February 2, 2023

Nicolas Roper
District Project Development Engineer
Virginia Department of Transportation, Northern Virginia District
4975 Alliance Drive, Fairfax, Virginia 22030

Re: Feedback on Arlington County Staff Recommendations for Route 1 Boulevard

ROUTE 1 CROSS SECTIONS

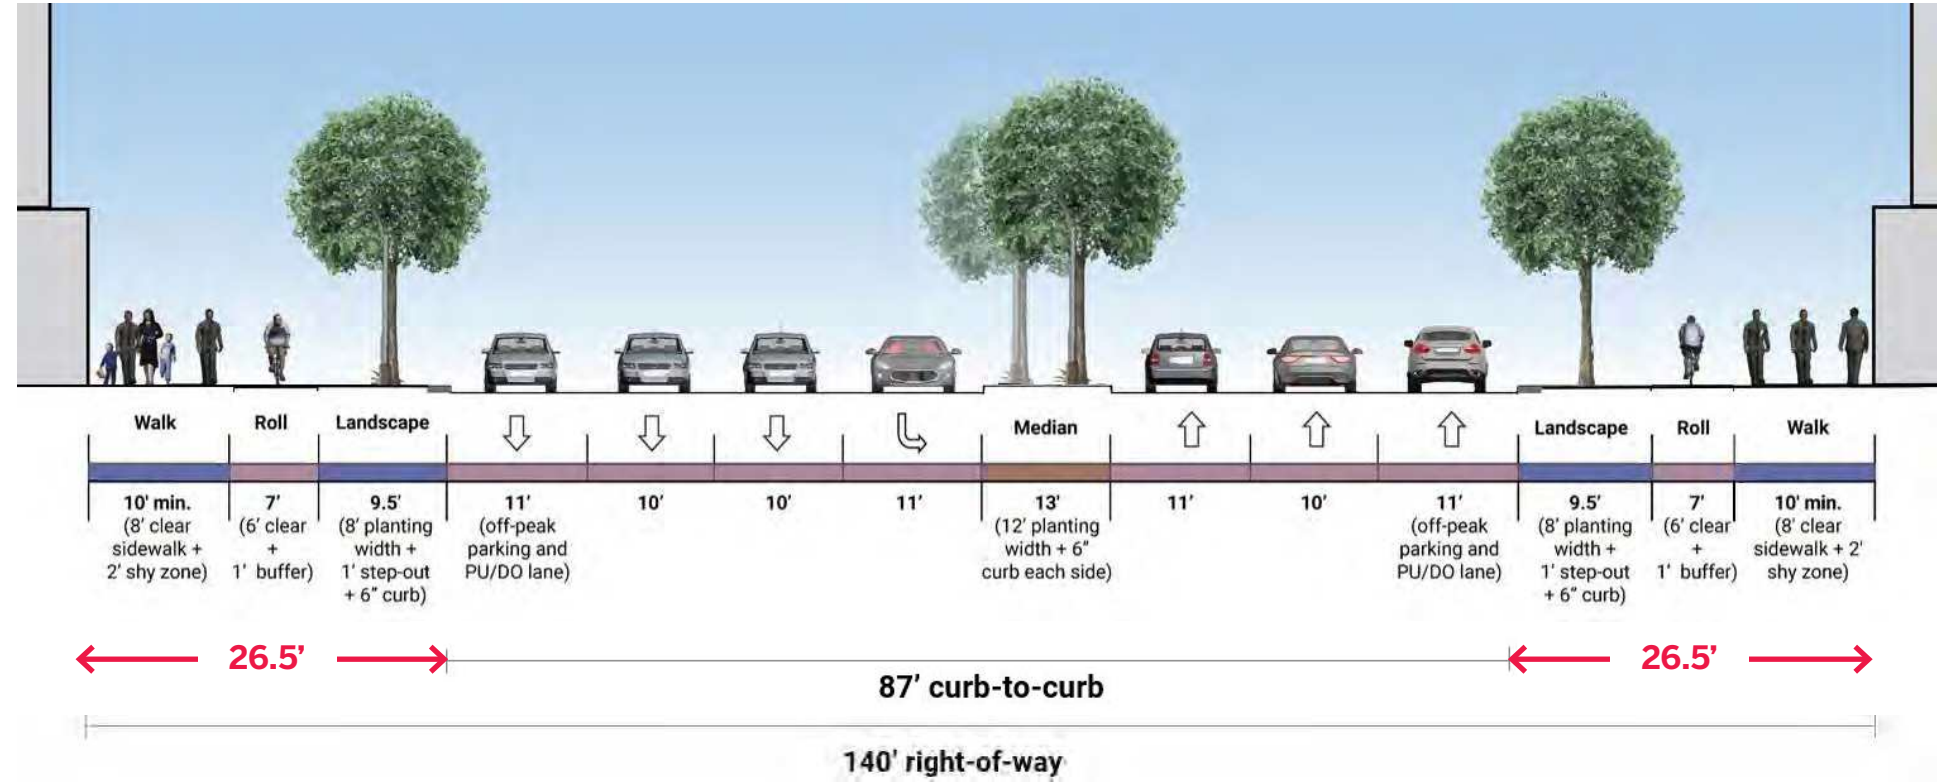
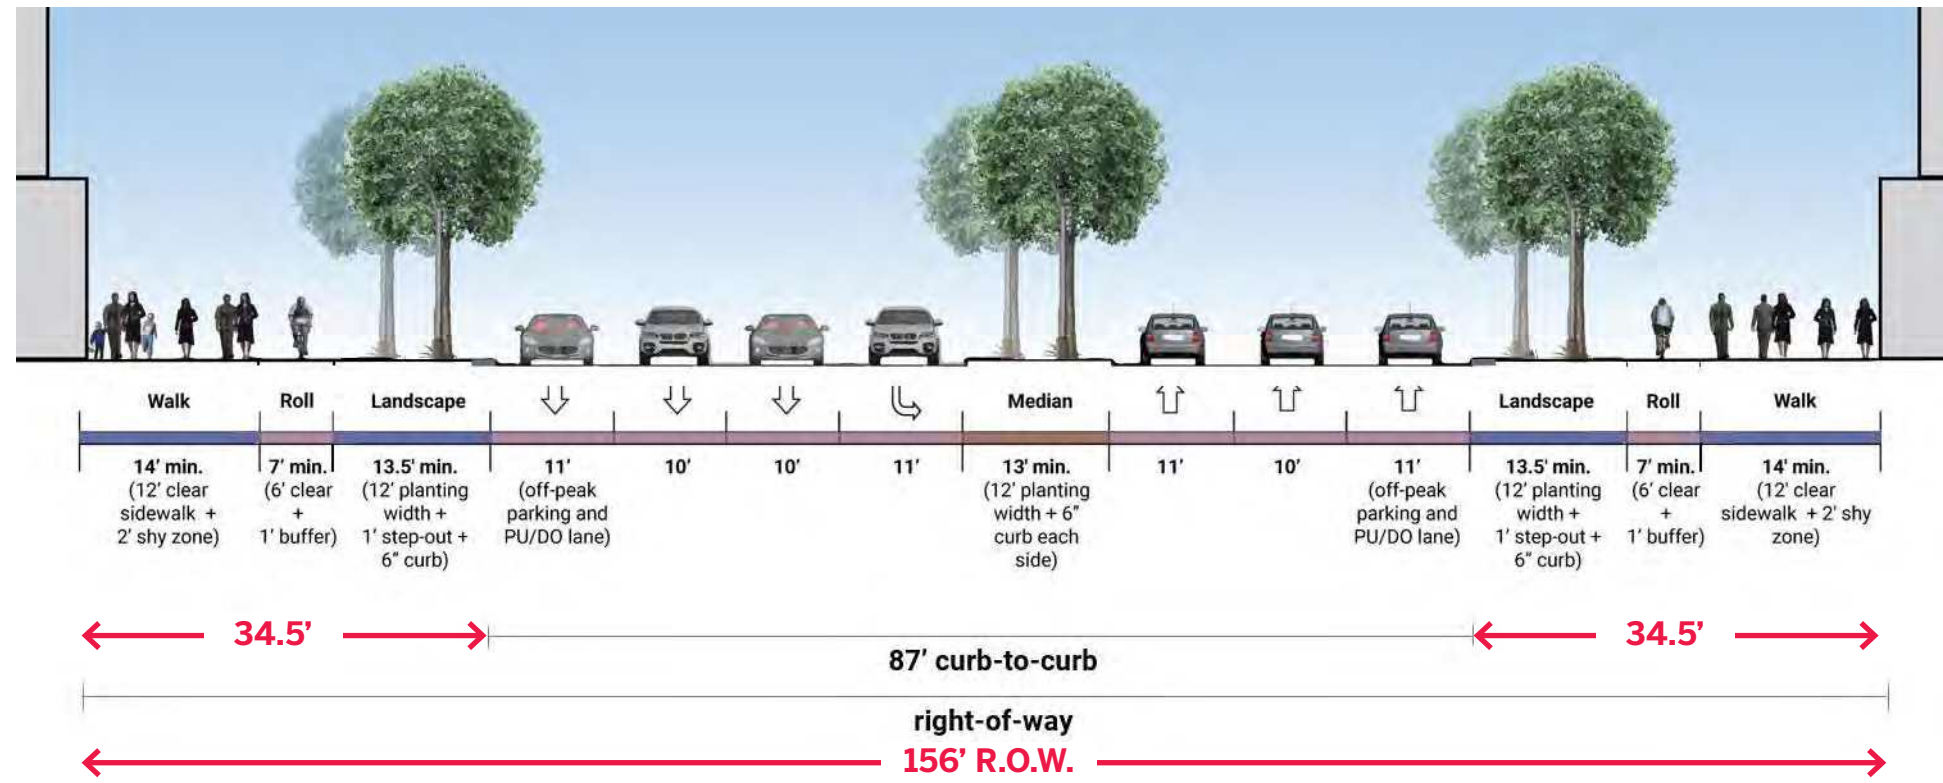
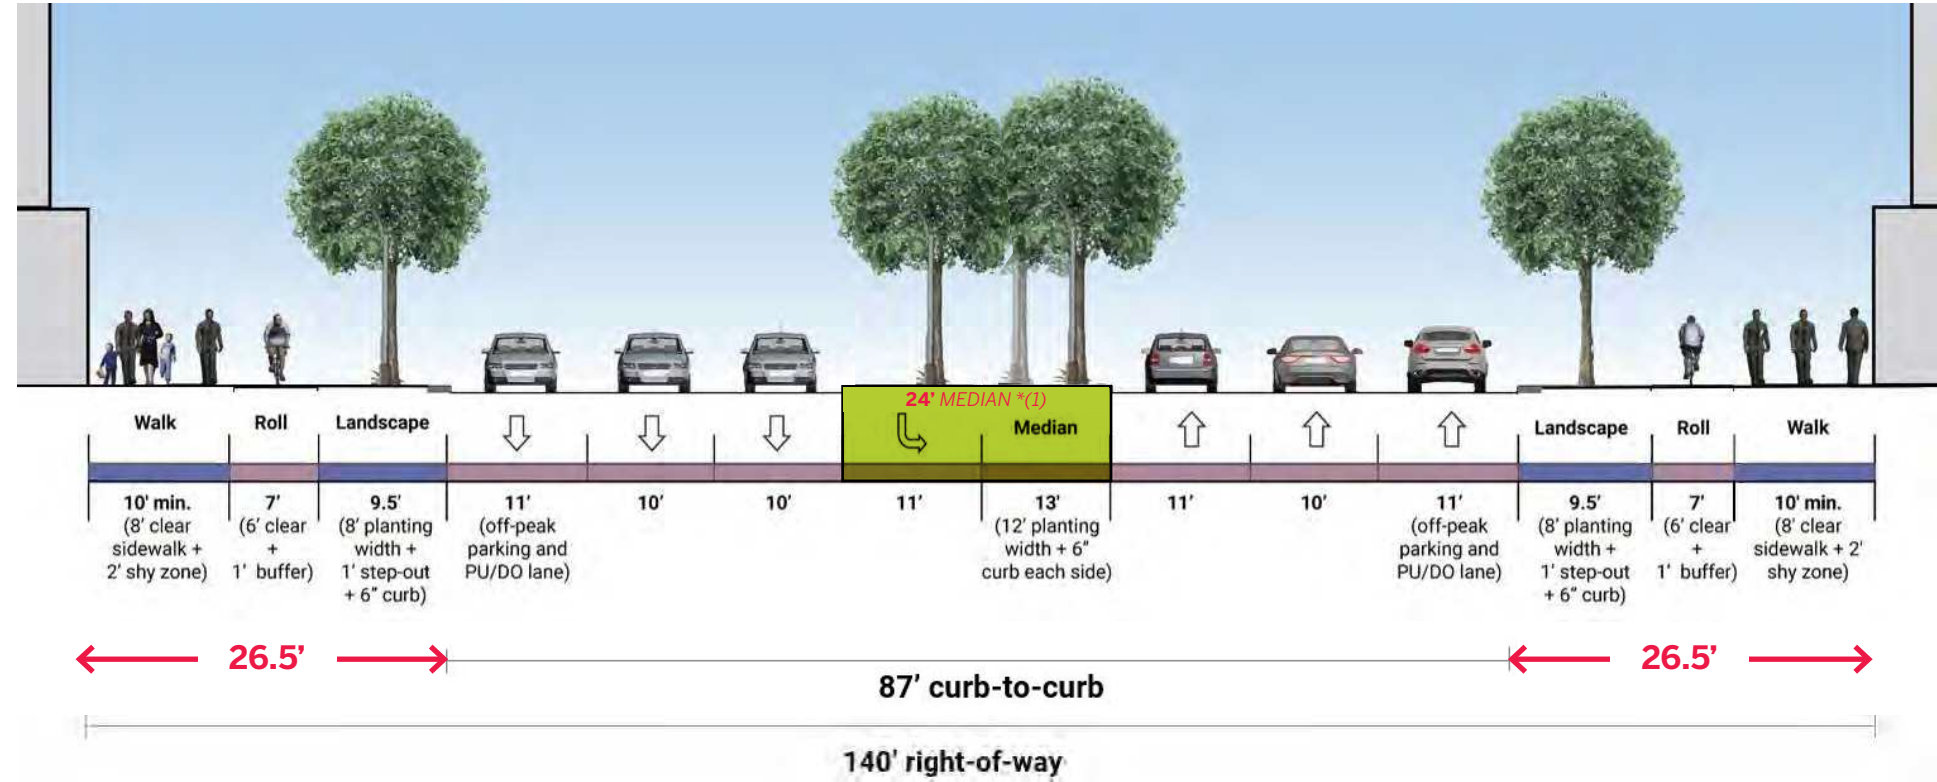
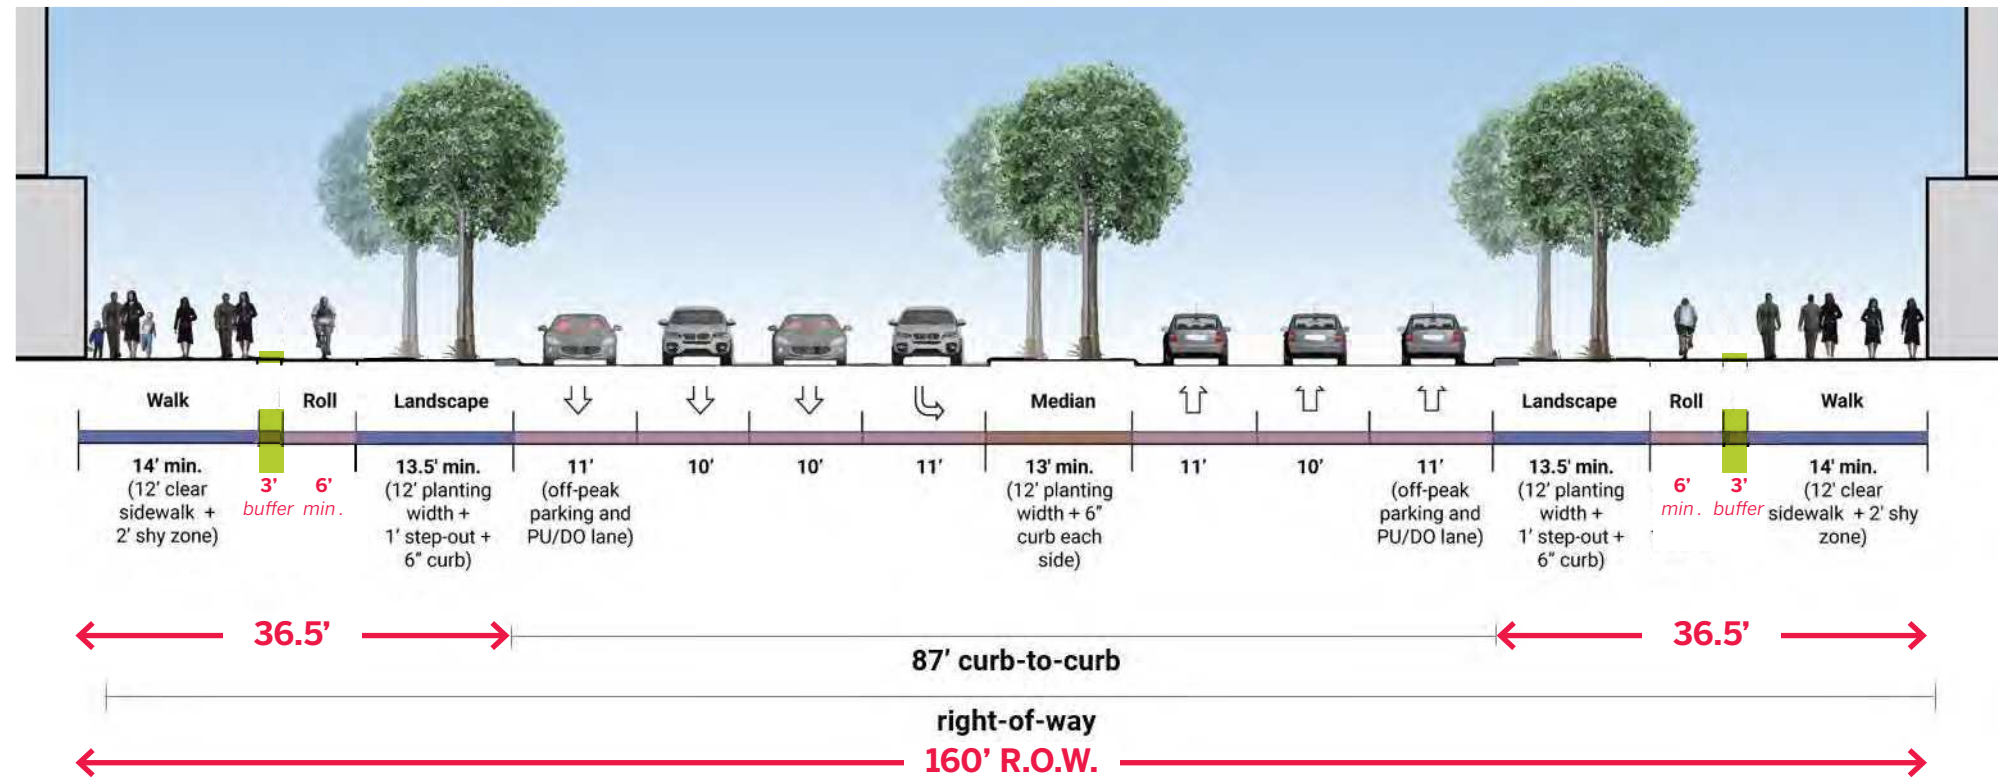
- *Midblock width*: the expanded ROW recommended by Arlington County north of 18th street includes a dedicated left turn lane, which is only required at intersections. For midblock

sections, the overall ROW could be reduced by 11' while maintaining county staff's recommended sidewalk and landscaping widths.

- *Median width:* County staff's recommended ROW north of 18th street includes a full width median and dedicated left turn lanes at intersections. VDOT's recommended ROW reduces the median width at intersections to accommodate turn lanes. Doing so here could reduce the overall ROW by up to 11' (depending on the size of the remaining median at the intersections) while maintaining county staff's recommended sidewalk and landscaping widths. The median width could be supplemented by reducing the proposed width of the curbside landscaping strips from 13.5' to 9.5' to match the proposed width south of 18th street.

RT 1 PARCELS - 140'/160' ROW - Comparison

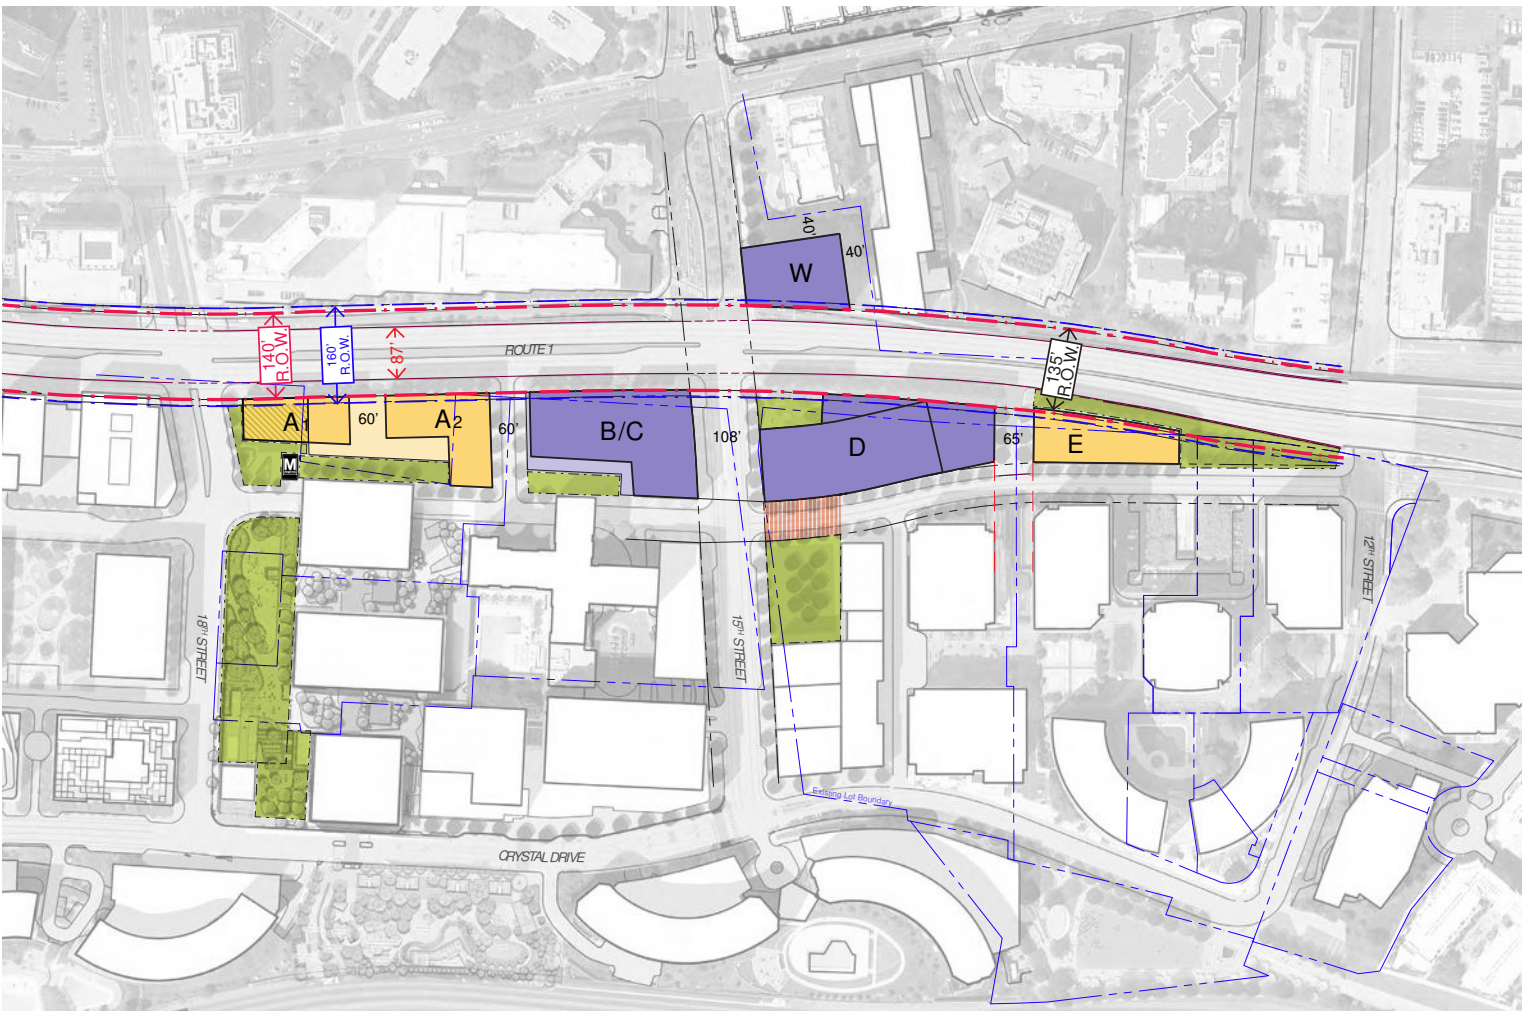
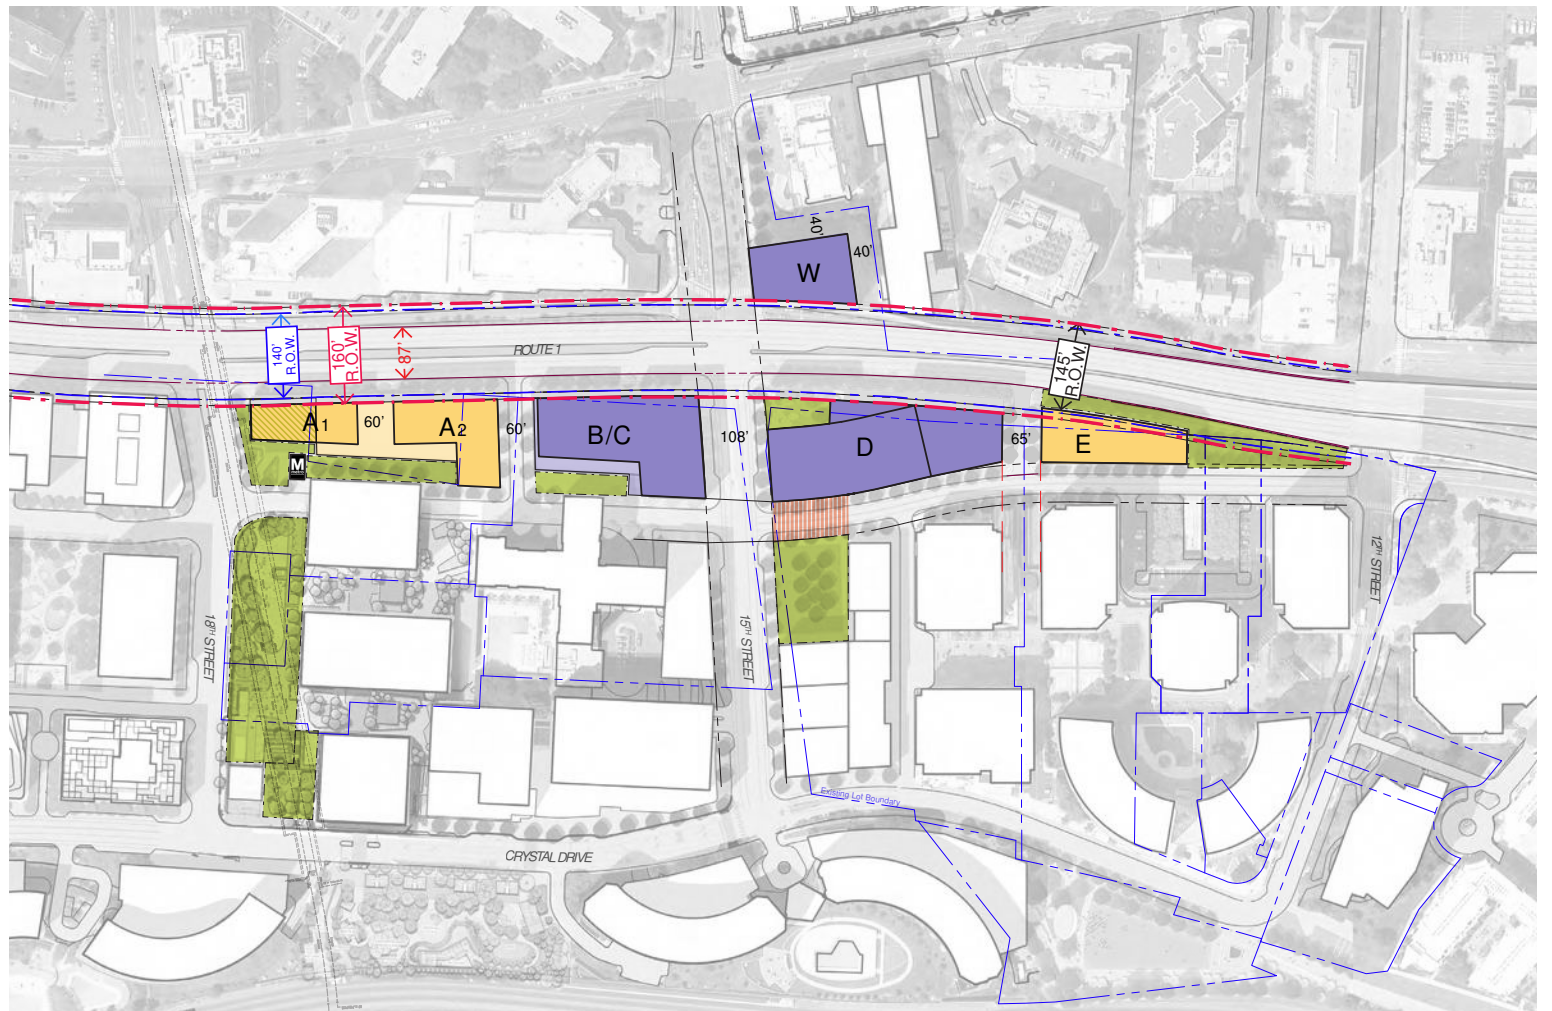
- *Eastern streetscape approaching 12th street:* We agree with the county's recommendation to shift the sidewalk/streetscape to the east between 12th and 15th streets to connect with the planned realigned Clark Street. As shown on figure 2, we believe that doing so would allow "Parcel E" to expand further east than would otherwise be possible while improving the bike/ped experience in that location and creating a mid-block corridor to further promote connectivity.
